## **OVERVIEW OF NYCT FACILITIES**

#### DOT BQE Map with NYCT Facilities

Furman Street at Clark, #7230 (Missing on Proposal)

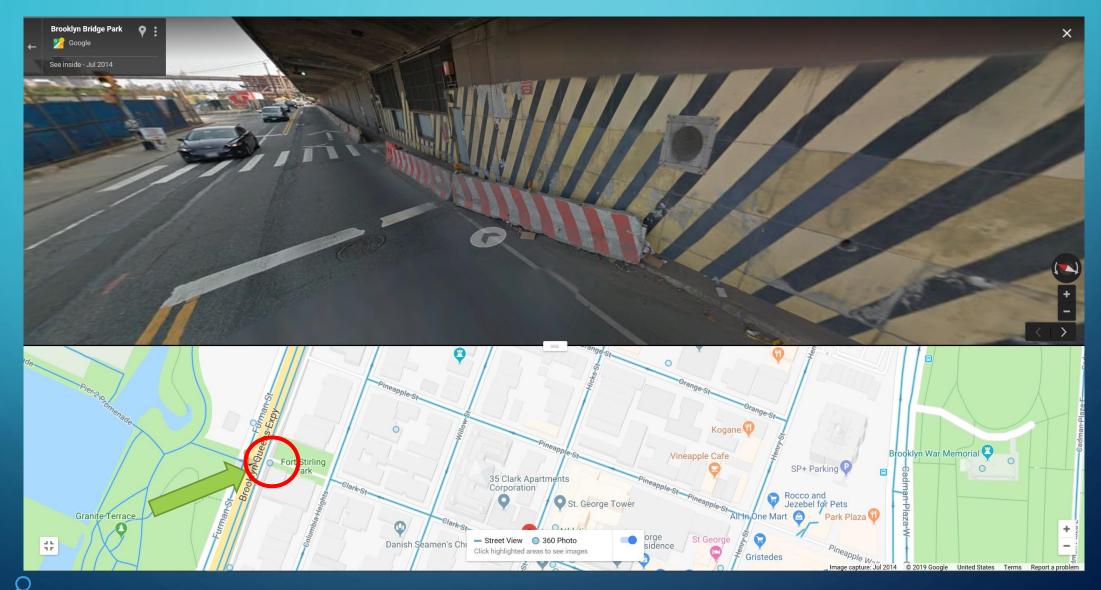
Furman Street at Clark, #7230 – Effects on this FP must be discussed
